COLORADO RIVER AND TRIBUTARIES, TEXAS,
COVERING MOUTH OF COLORADO RIVER

LETTER
FROM
THE SECRETARY OF THE ARMY
TRANSMITTING

A LETTER FROM THE CHIEF OF ENGINEERS, DEPARTMENT OF THE ARMY, DATED JULY 23, 1968, SUBMITTING A REPORT, TOGETHER WITH ACCOMPANYING PAPERS AND ILLUSTRATIONS, ON COLORADO RIVER AND TRIBUTARIES, TEXAS, COVERING MOUTH OF COLORADO RIVER, IN PARTIAL RESPONSE TO A RESOLUTION OF THE COMMITTEE ON COMMERCE, UNITED STATES SENATE, ADOPTED AUGUST 4, 1936

FIGURE 1

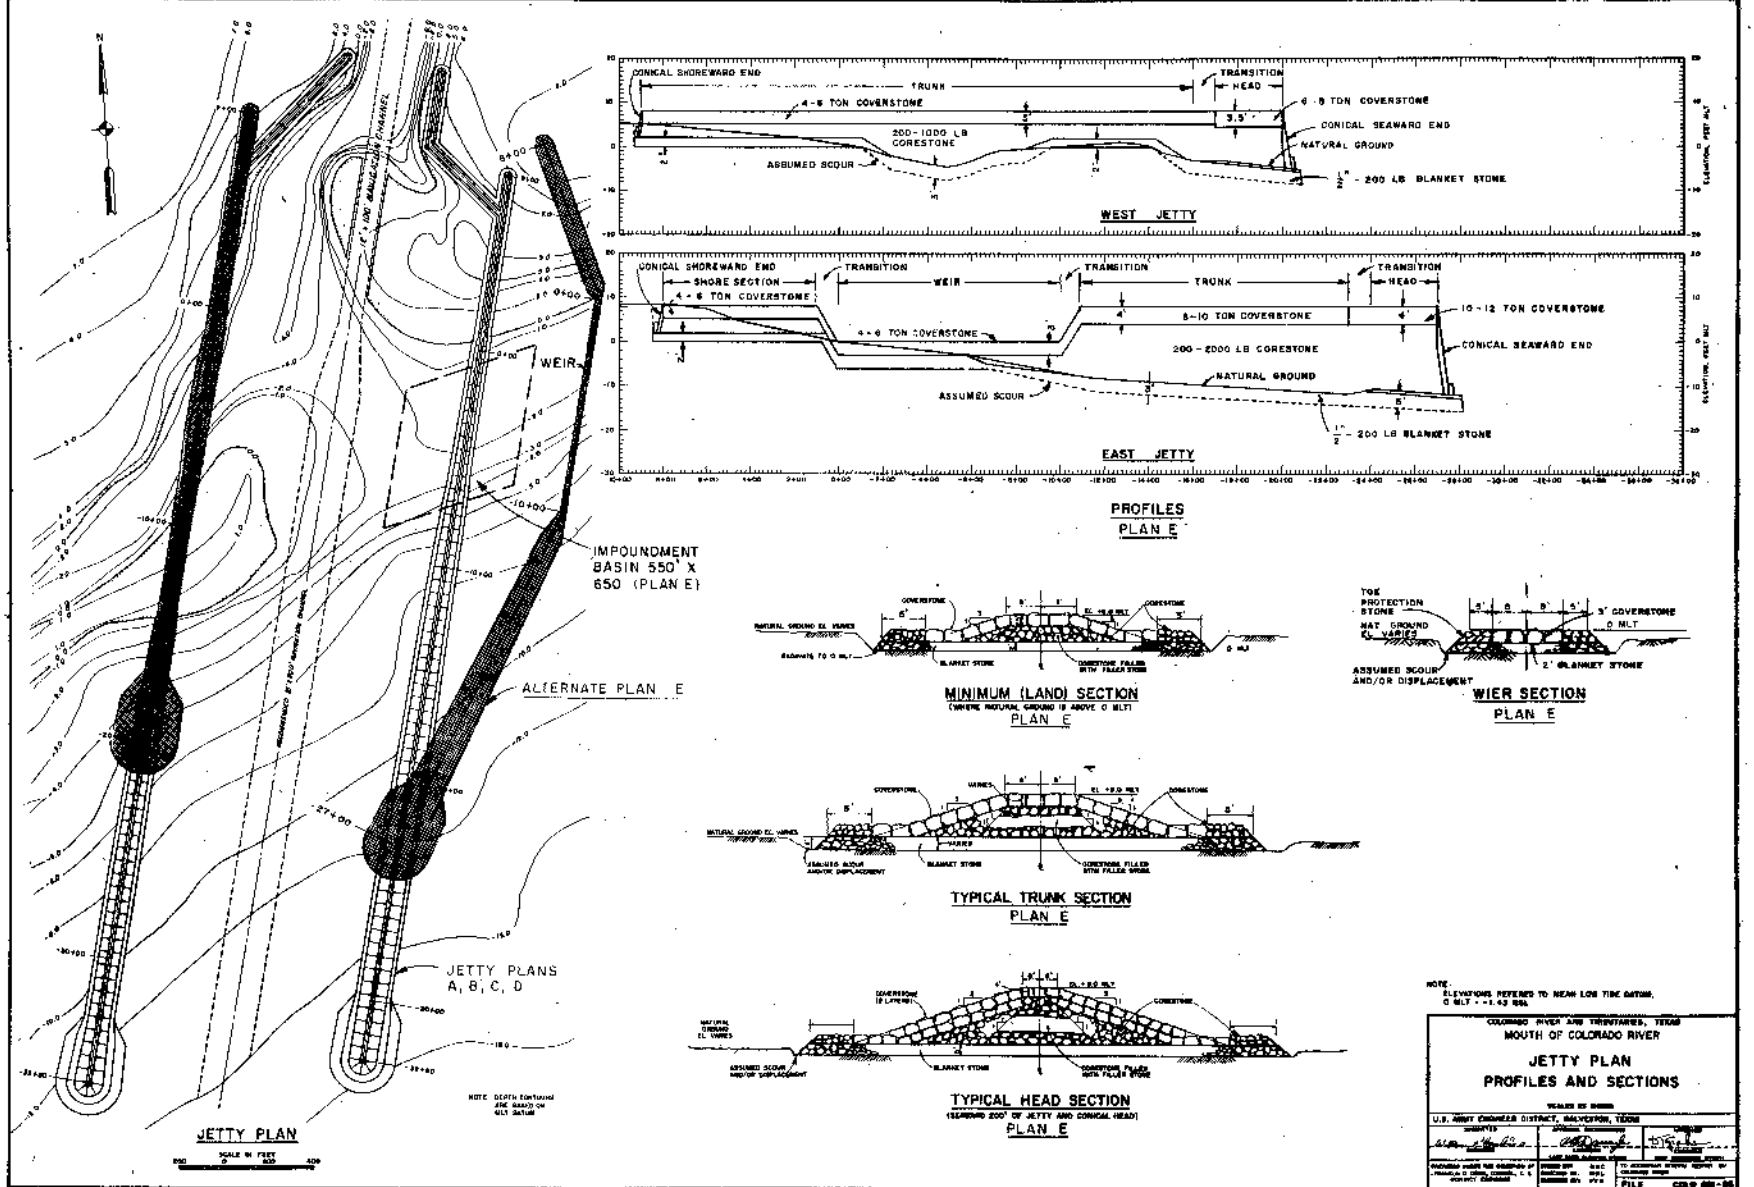
2. RECOMMENDATIONS OF THE COASTAL ENGINEERING RESEARCH CENTER.- As a fifth alternate to the plans of improvement investigated in the interim report on the Mouth of the Colorado River dated 29 December 1967, CERC has recommended that the jetty design be modified to provide a weir type east jetty and impoundment basin to provide for the dual purposes of channel maintenance and prevention of downdrift beach erosion; that the east jetty be terminated at the 12-foot depth contour; and that the west jetty be shortened to the minimum feasible length.

4. The modified jetty plan is shown on figure 1. The jetties would be rubble mound stone construction as described in the interim report, with crest elevation at 8 feet above MLT. A 1000-foot section of the east jetty, extending from the shoreline seaward, would have a crest elevation of 0 MLT to allow passage of beach material across the jetty to an impoundment basin inside the jetty. The impoundment basin would be dredged periodically and the material pumped across the west jetty and deposited on the downdrift beach. The east jetty would terminate at the 12-foot depth contour. The west jetty would terminate at the 5-foot depth contour. Typical jetty sections, stone sizes, and jetty profiles are shown on figure 1.

7. JETTY DESIGN.- Design of the modified jetty plan is based on the criteria presented in Appendix II of the interim report. Lengths and configuration of the east jetty and weir section are based on recommendations of the Coastal Engineering Research Center. The length of the west jetty was determined on the basis of the amount of accretion at the west jetty of Matagorda Ship Channel (24 miles to the southwest), and is considered to be the minimum feasible length. A modification in coverstone size was also incorporated into the alternate jetty design. Experience subsequent to design of the jetties proposed in the interim report has shown that the 2-4 ton coverstone is subject to frequent displacement. This and the fact that 2-4 ton stone has a much higher placement cost than 4-6 ton stone resulted in the decision to eliminate 2-4 ton stone from the alternate jetty design. This modification would also be applicable to the jetty design proposed in the interim report. The effect of this modification on first costs of the interim report design has not been evaluated.
